**BOARD OF ZONING ADJUSTMENT  
STAFF REPORT****Date: March 11, 2019****CASE NUMBER**

6243/5603

Church Street Apartments, LLC

**LOCATION**1400 Church Street  
(Northwest corner of Church Street and Everett Street)**VARIANCE REQUEST****USE:** Use Variance to allow an apartment building in an R-1, Single-Family Residential District.**PARKING RATIO:** Parking Ratio Variance to allow a reduced number of parking spaces.**ACCESS AND MANEUVERING:** Access and Maneuvering Variance to allow substandard access width.**FRONT LANDSCAPING:** Front Landscaping Variance to allow reduced front landscaping.**ZONING ORDINANCE  
REQUIREMENT****USE:** The Zoning Ordinance does not allow an apartment building in an R-1, Single-Family Residential District.**PARKING RATIO:** The Zoning Ordinance requires a compliant number of parking spaces to be provided.**ACCESS AND MANEUVERING:** The Zoning Ordinance requires compliant access and maneuvering space be provided.**FRONT LANDSCAPING:** The Zoning Ordinance requires compliant front landscaping area be provided.**ZONING**

# SITE PLAN

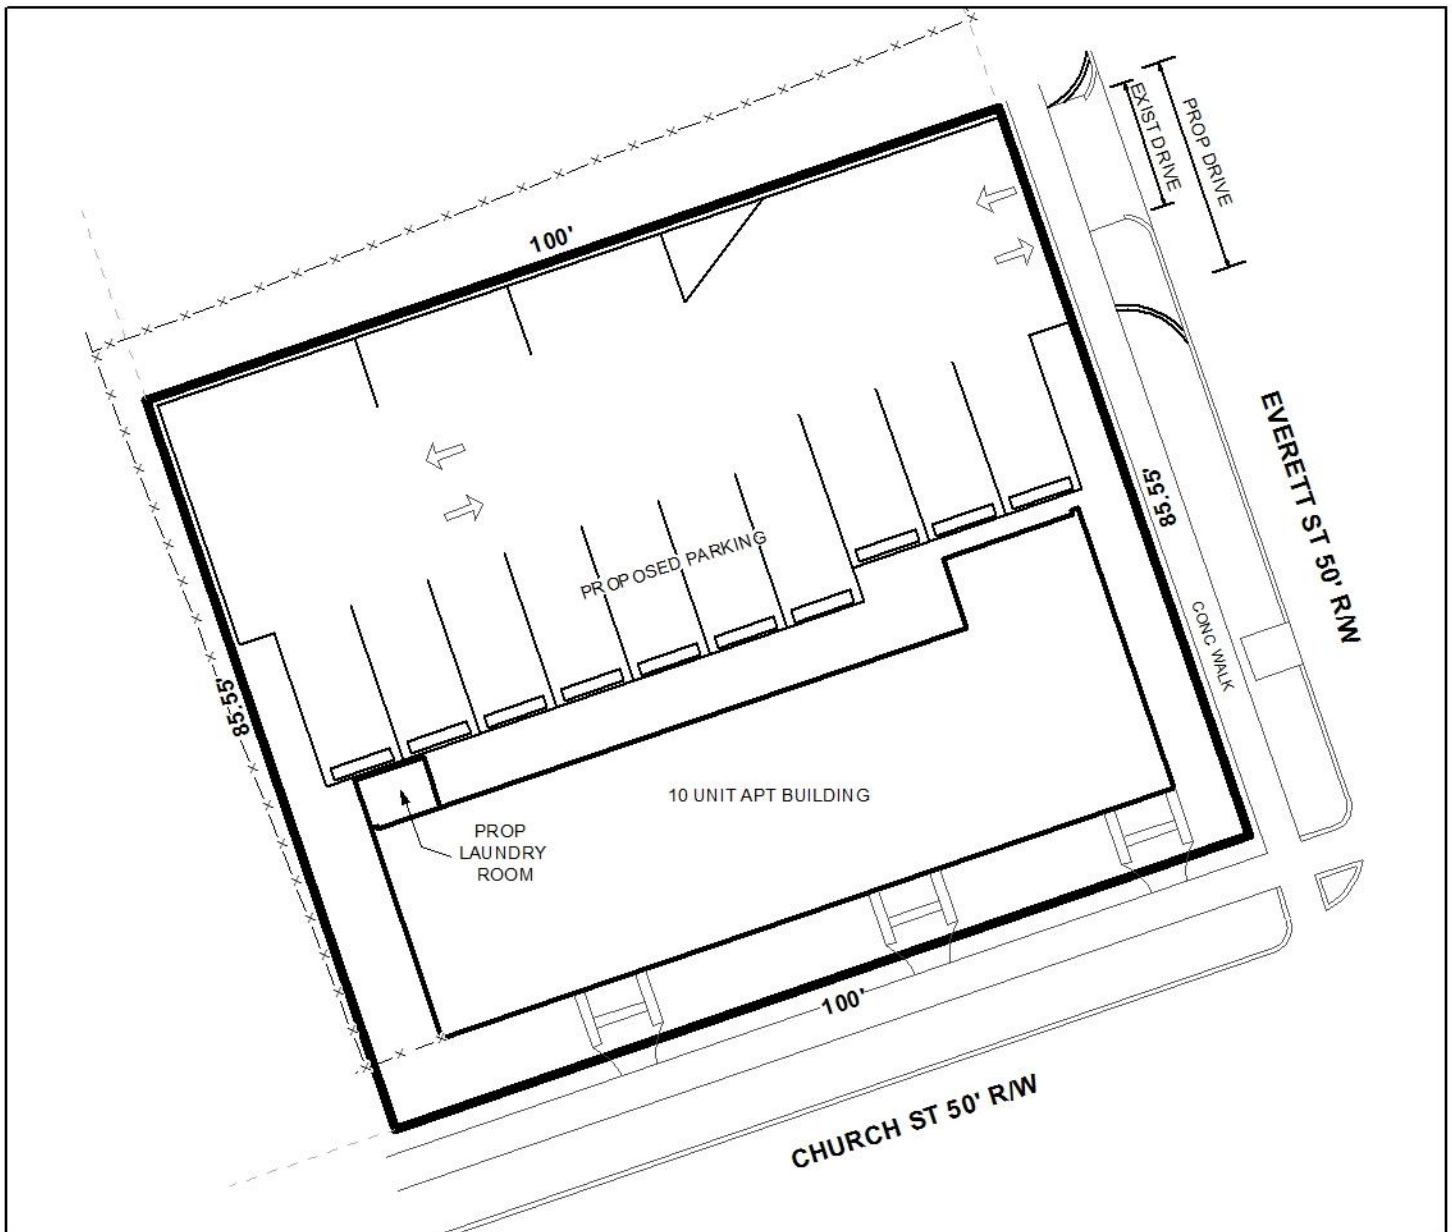
For ten apartment units, the site is required to provide 15 parking spaces. The site plan provided indicates ten compliant nose-in/back-out 90-degree parking spaces along the North side of the building, and two non-compliant parallel parking spaces along the Northern boundary of the site. Those two spaces are indicated to be 8' wide and 18' long. Parallel parking stalls must be 9' wide, and interior stalls must be at least 23' long. End stalls must be at least 20' long if their entry/exit area is unencumbered. It appears that sufficient area exists to at least meet the minimum length requirements for these two parking spaces; however, the restricted maneuvering area between the rear of the 90-degree parking stalls and the side of the parallel parking stalls is a concern. Site entry and exit is indicated via a compliant 24' wide curb cut with compliant 24' access and maneuvering area behind the first three parking stalls West of the entrance. Beyond that point, the access and maneuvering area diminishes to 20' between the rear of the 90-degree parking stalls and the side of the parallel parking stalls. Therefore, the two parallel parking stalls should be eliminated and a 24' access/maneuvering aisle should be provided. The previously-approved Parking Ratio Variance request was approved for nine parking spaces, and the applicant now proposes ten compliant spaces, excluding the parallel parking spaces.

With regard to the Front Landscaping Variance request, landscaping calculations on the site plan indicate 585 square feet of landscaping within the area between the front of the building and the Church Street right-of-way. The required frontage landscaping for the site is 616 square feet. Since this is a public street corner site, the required frontage landscaping can be apportioned along both street frontages, and there is an area of 204 square feet between the East end of the building and the Everett Street right-of-way which can also be counted into the total frontage landscaping area, thus providing a total of 789 square feet of frontage landscaping area. Therefore, the Frontage Landscaping Variance request is not needed.

- 1) Approving the variance will be contrary to the public interest in that its allowance would cause a restricted maneuvering area between the 90-degree and parallel parking areas;
- 2) Special conditions were not illustrated such that the literal enforcement of the provisions of the chapter will result in an unnecessary hardship because the elimination of the proposed parallel parking spaces will still allow one more compliant parking space than provided in the previously-approved variance; and
- 5) The spirit of the chapter shall not be observed and substantial justice shall not be done to the surrounding neighborhood by granting the variance because it could cause traffic back-up into the right-of-way due to restricted on-site traffic flow.

- 1) revision of the site plan to eliminate the two parallel parking spaces along the Northern boundary of the site and provide a 24' wide access/maneuvering area along the rear of all parking stalls;
- 2) correction of the front landscaping calculations to indicate that compliant area is provided;
- 3) submittal to and approval by Planning and Zoning of a revised site plan; and
- 4) full compliance with all municipal codes and ordinances.
